Intel® Desktop Board D865GLC Specification Update

Release Date: November 2004

Order Number: C41598-012

Specification Update for the Intel® Desktop Board D865GLC

Figure 29a. Omnidirectional Airflow Heatsink

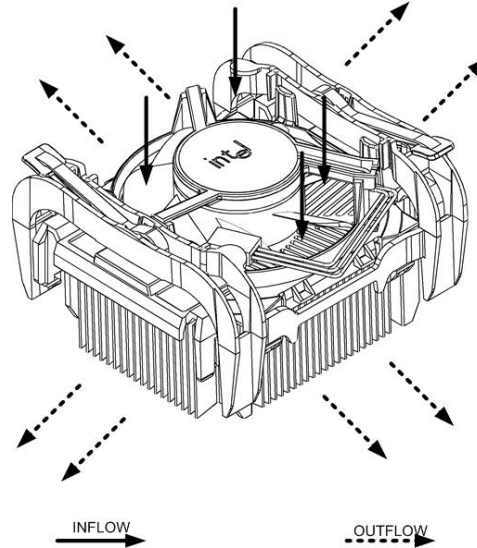
5. Change to Thermal Considerations, Section 2.12

Section 2.12, Thermal Considerations will change in its entirety as follows:

The use of an Intel Pentium 4 processor with 1 MB of L2 cache on this Intel desktop board requires the following:

- A chassis with a maximum internal ambient temperature of 38 Degrees Celsius
- A processor heatsink that provides omnidirectional airflow so that air is drawn across the processor voltage regulator area (item A in Figure 30). Figure 29a illustrates an omnidirectional airflow heatsink.

Figure 30. Localized High Temperature Zones

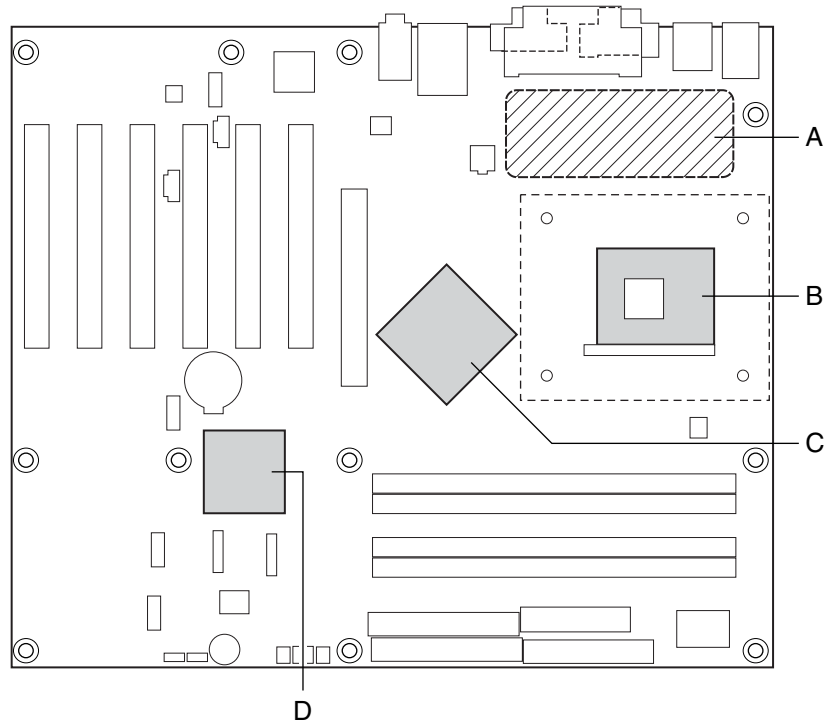
Ensure that proper airflow is maintained in the processor voltage regulator circuit. Failure to do so may result in damage to the voltage regulator circuit. The processor voltage regulator area (item A in Figure 30) can reach a temperature of up to 85 °C in an open chassis.

Figure 30 shows the locations of the localized high temperature zones.
